Addendum No. 1
Date: January 30, 2026

**Addition to
Andalusia Elementary School for the
Andalusia City Schools
Andalusia, Alabama**

MCKEE PROJECT NO. 24-304

ALABAMA DIVISION OF CONSTRUCTION MANAGEMENT NO. 2025681

A4.1

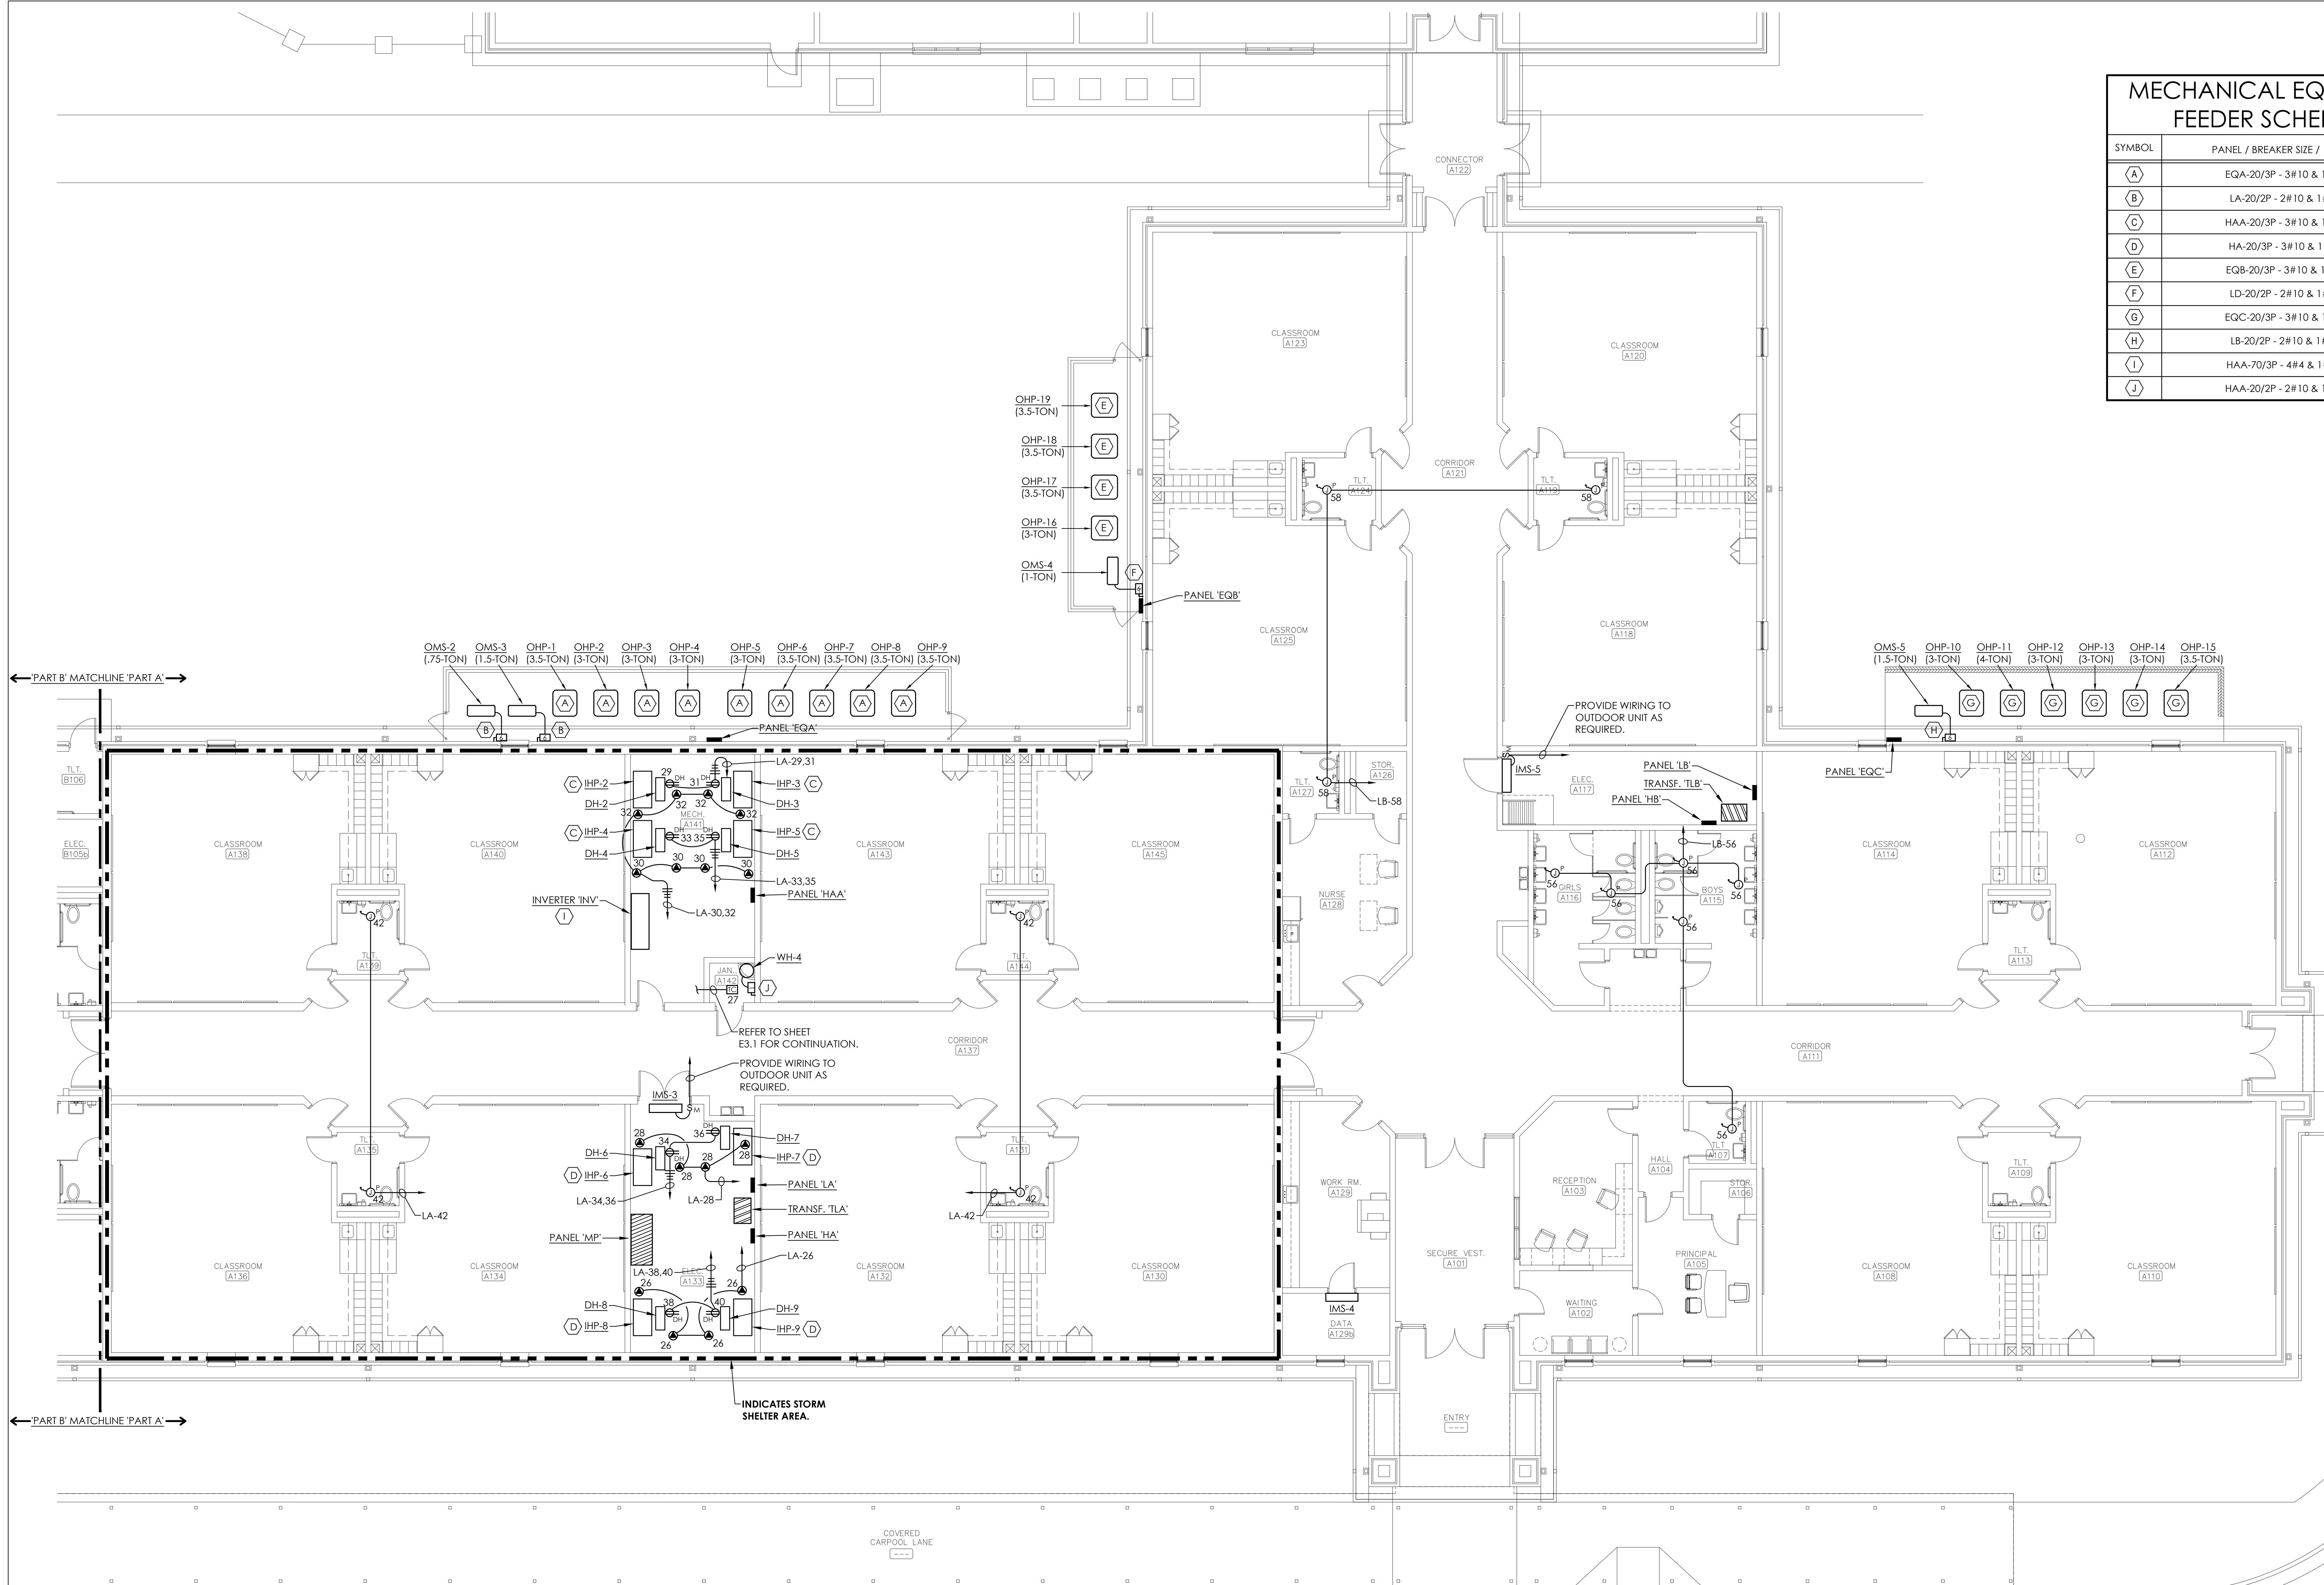
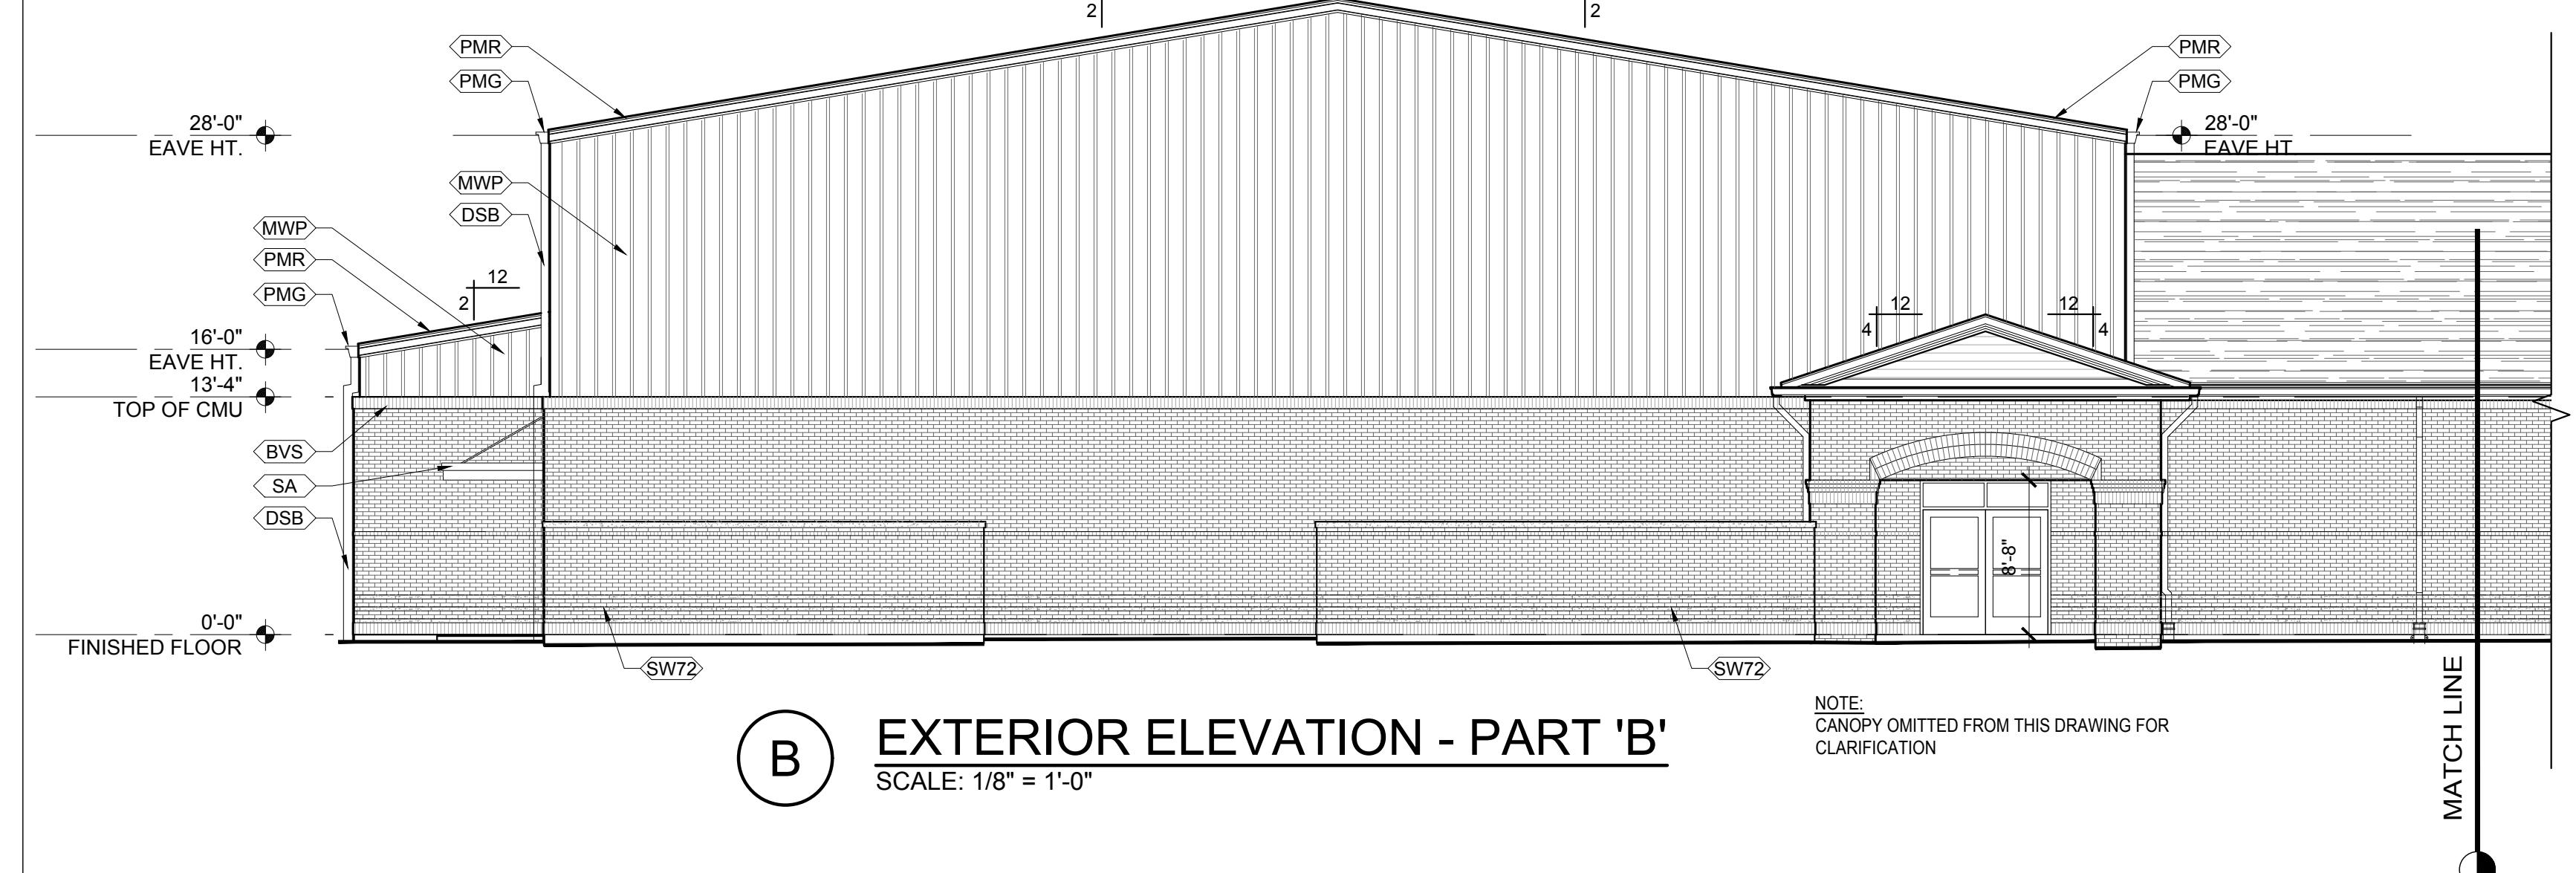
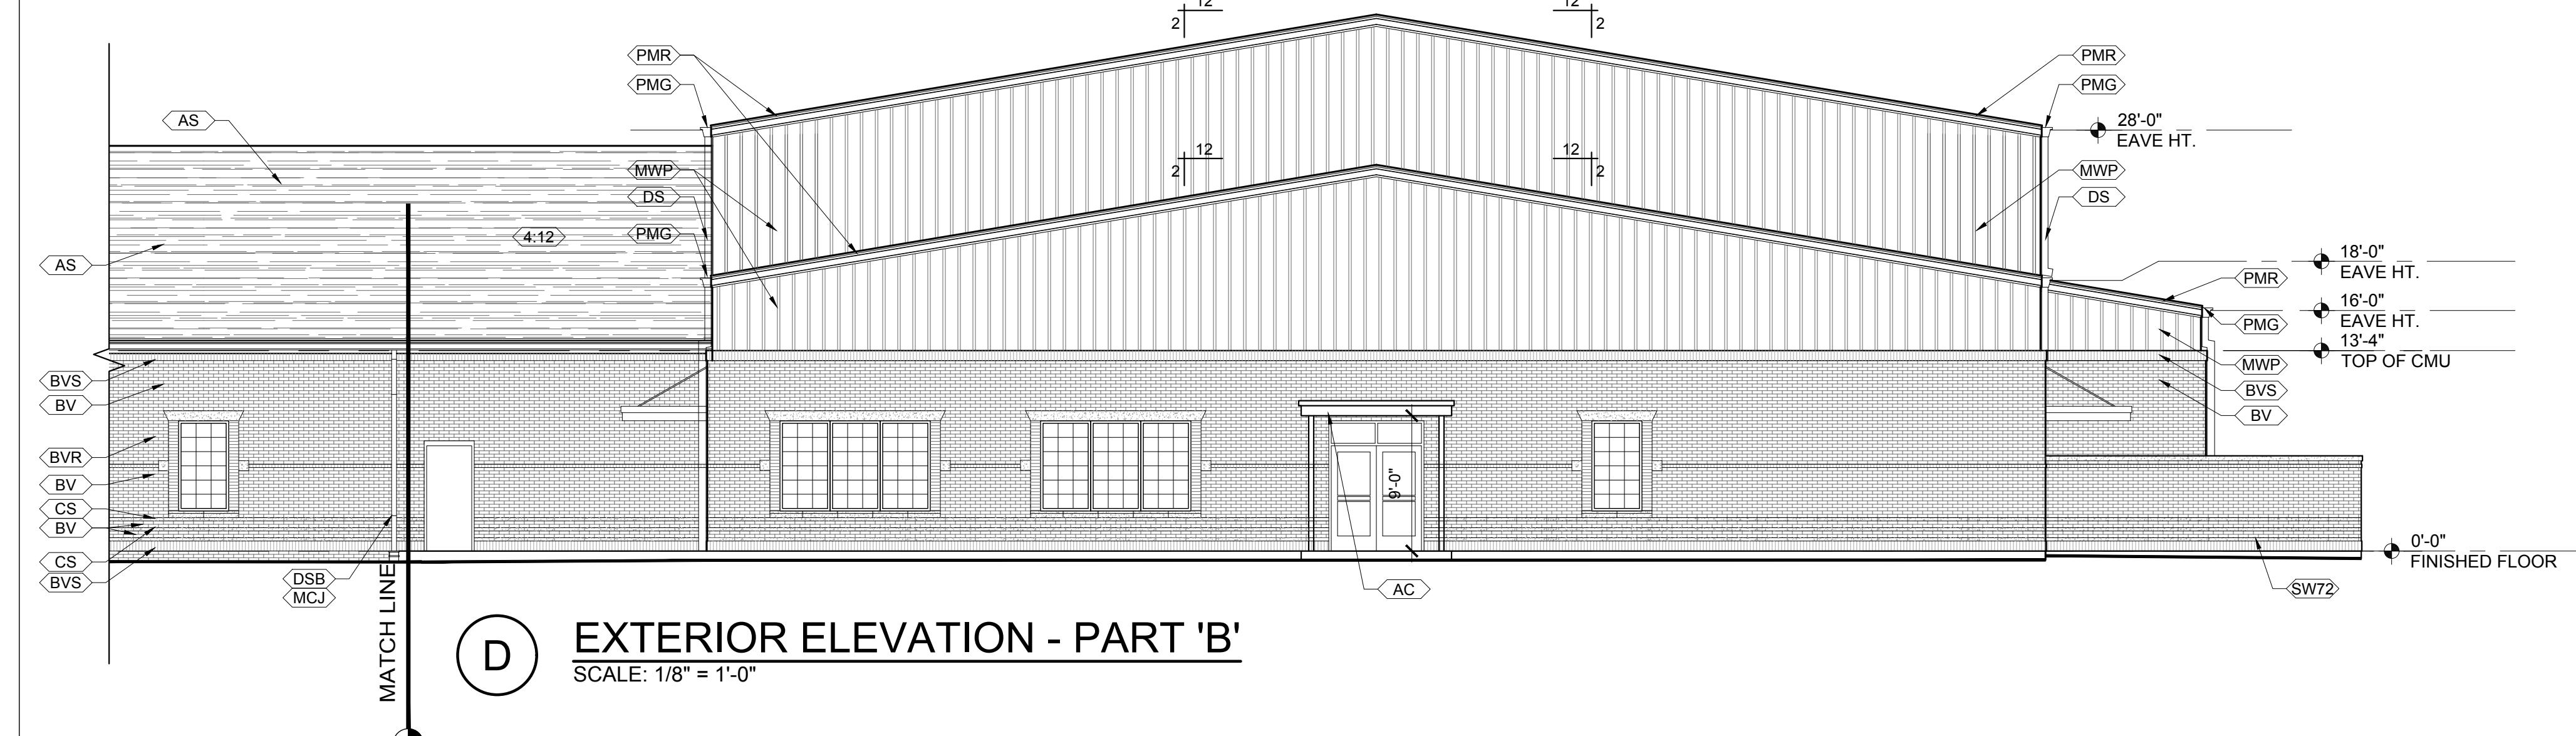
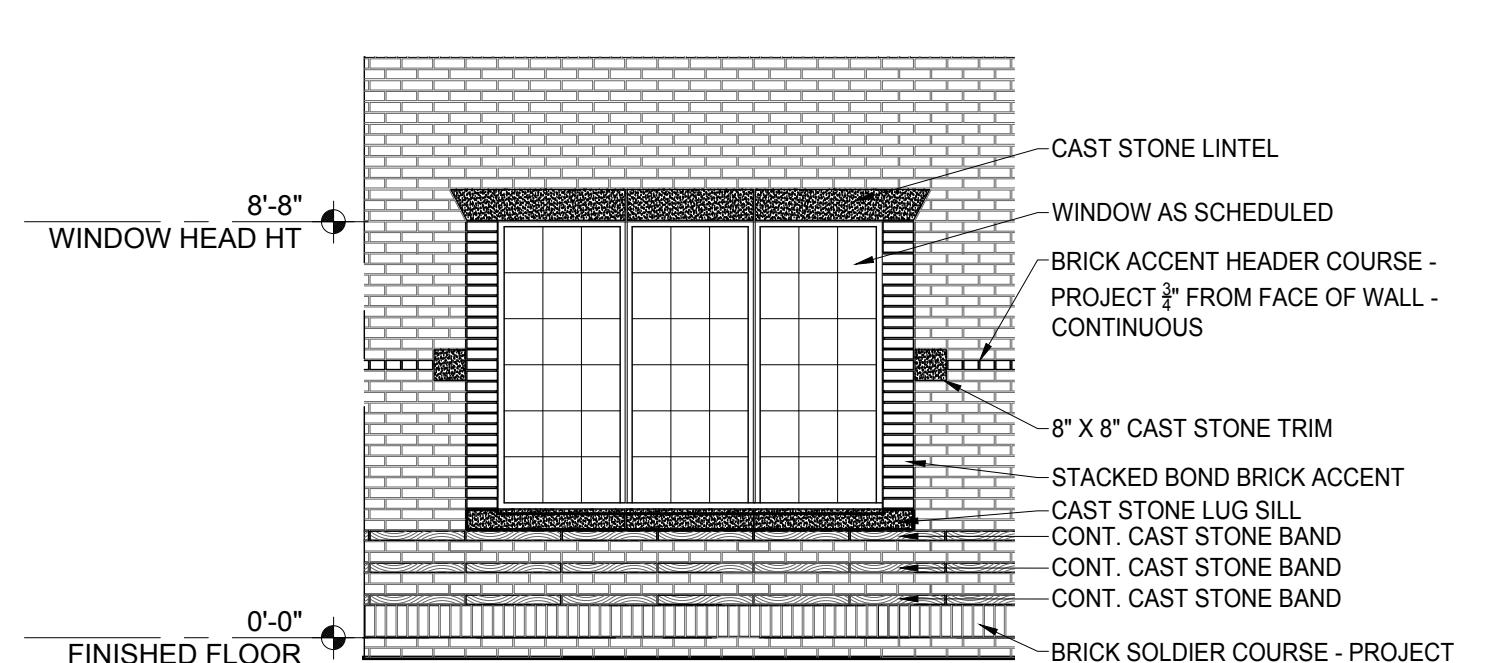
NOTE:
CANOPY OMITTED FROM THIS DRAWING
CLARIFICATION
